## 5.0 Viaduct Arches (Building V)

### 5.8 Revised Scheme-

### 6.1 Permitted Planning Scheme

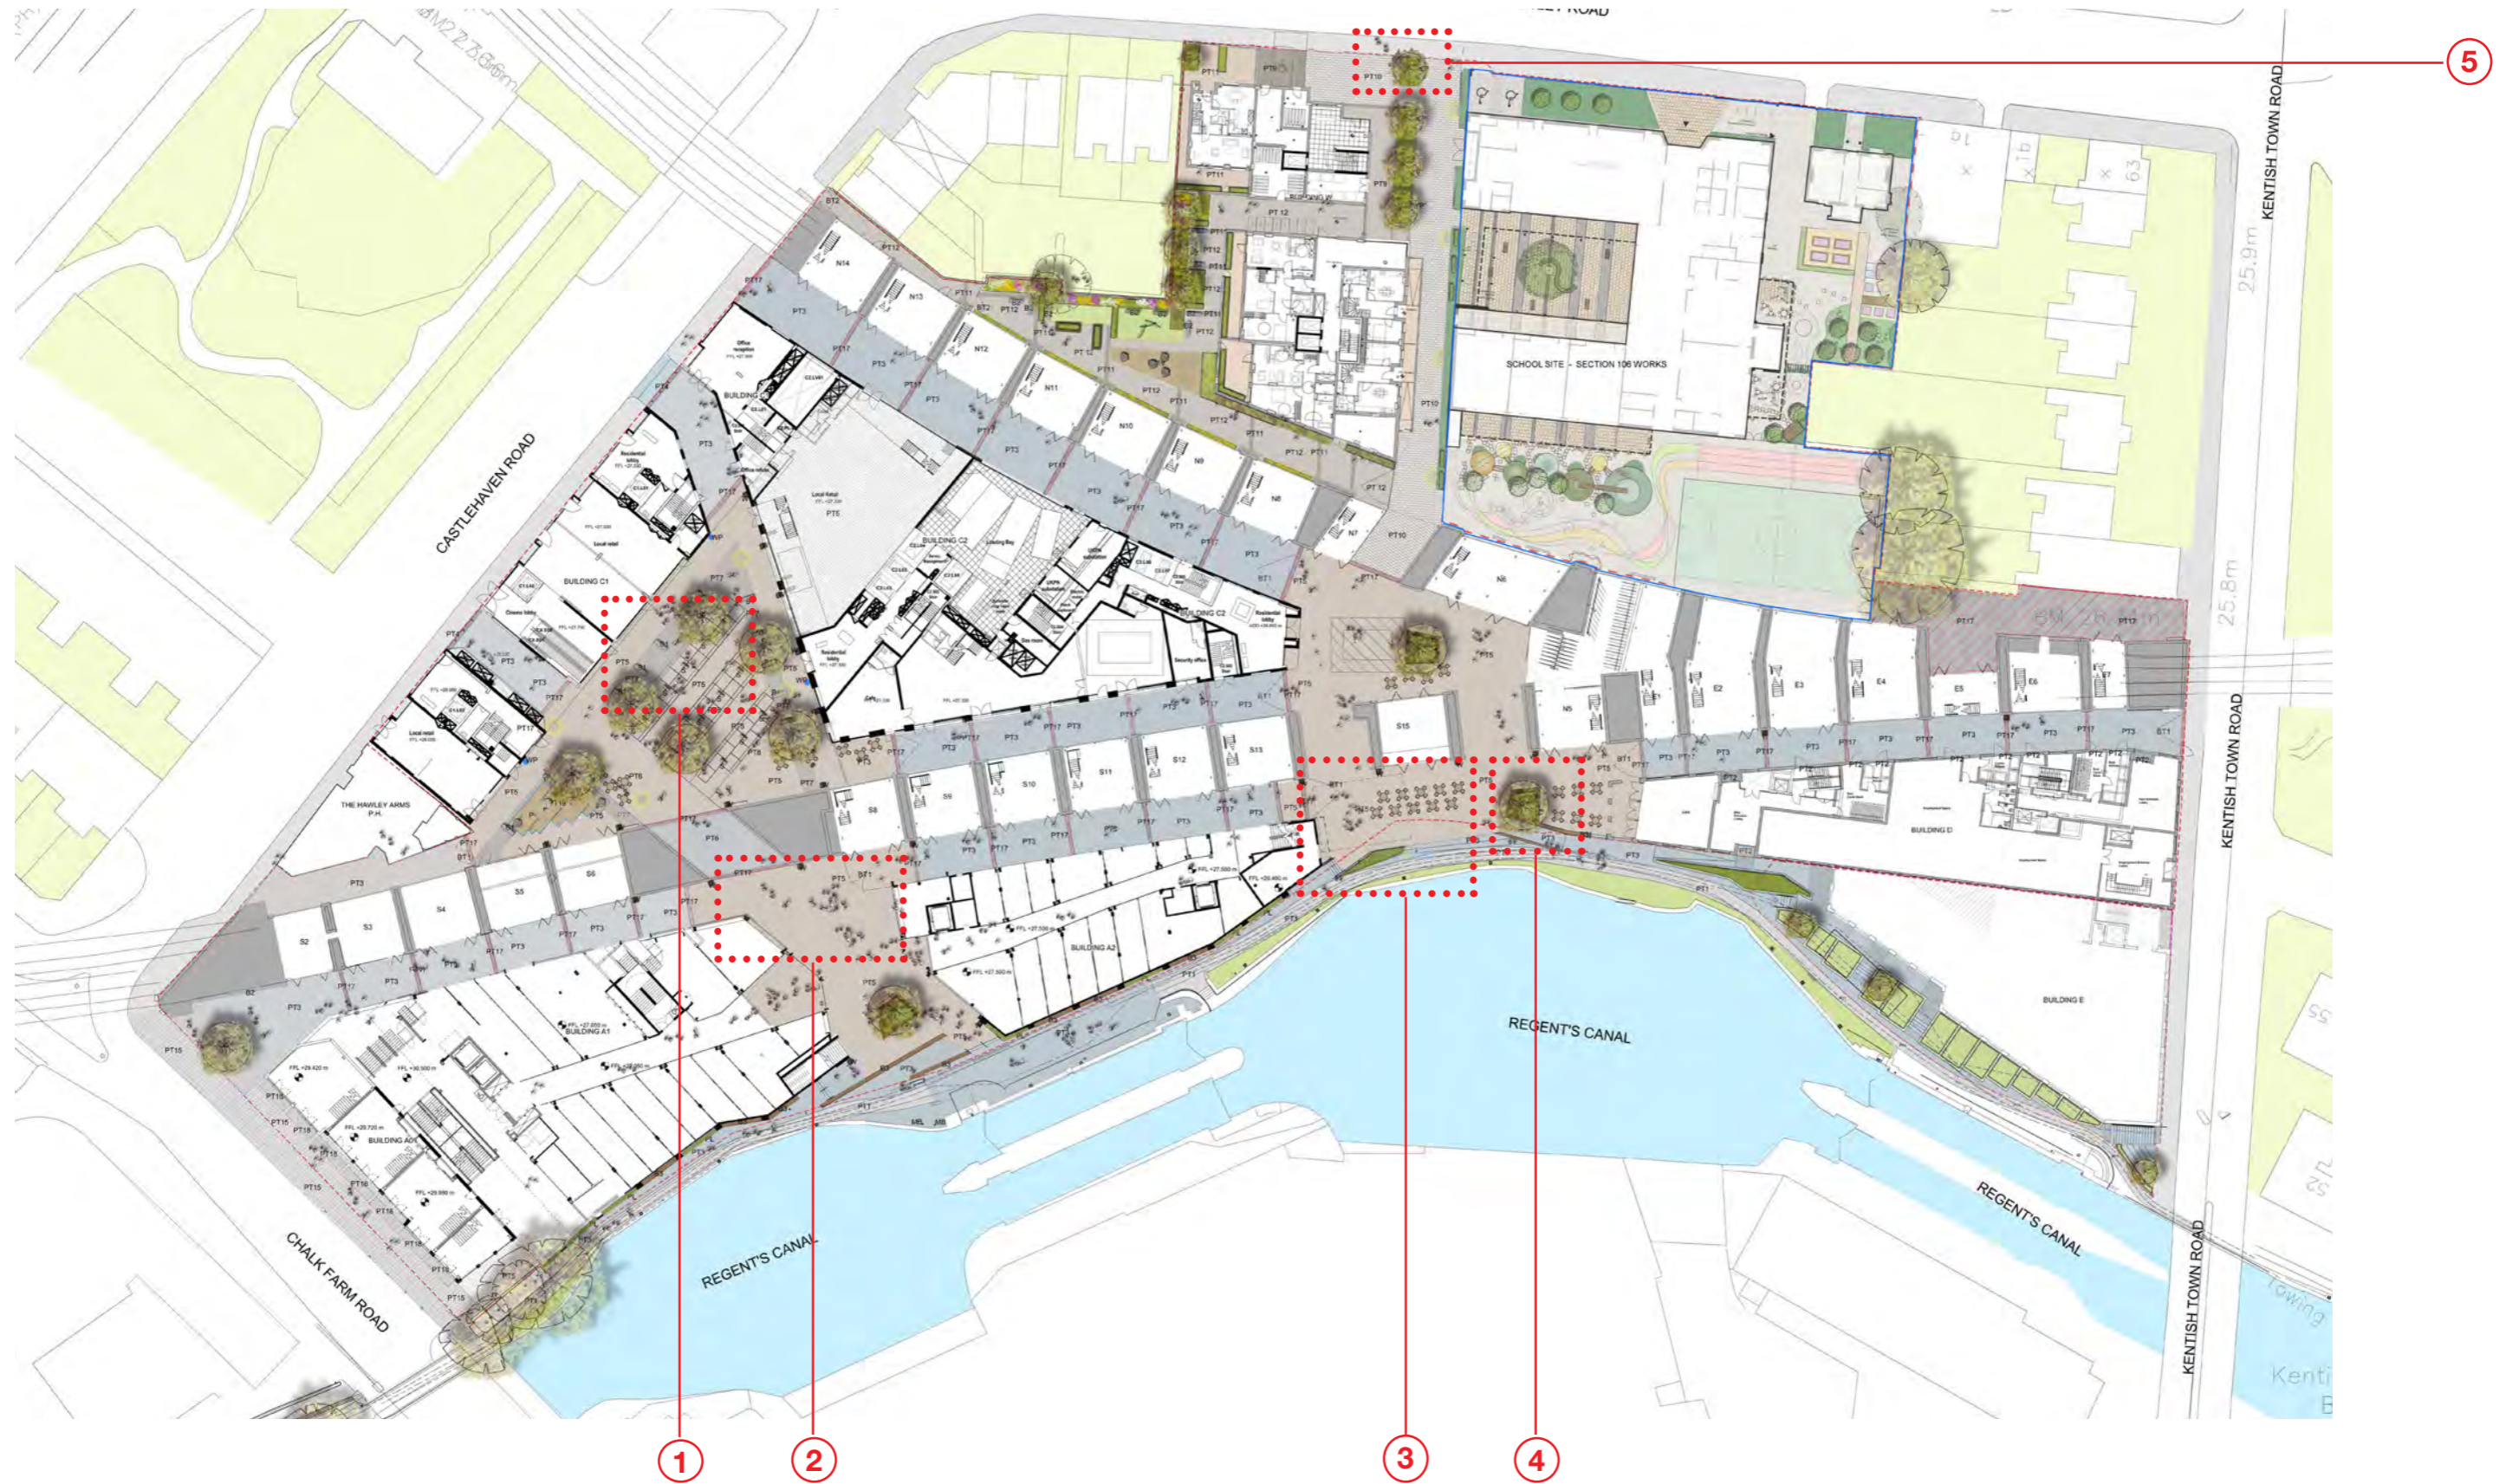
- 1** One tree removed after coordination with basement, but relocated as per item 5.
- 2** Isolated benches removed
- 3** Levels revised to allow for existing underground services
- 4** One larger tree, replacing two medium trees due to UKPN access requirements
- 5** New tree added to reduce possibility of unwanted vehicular access
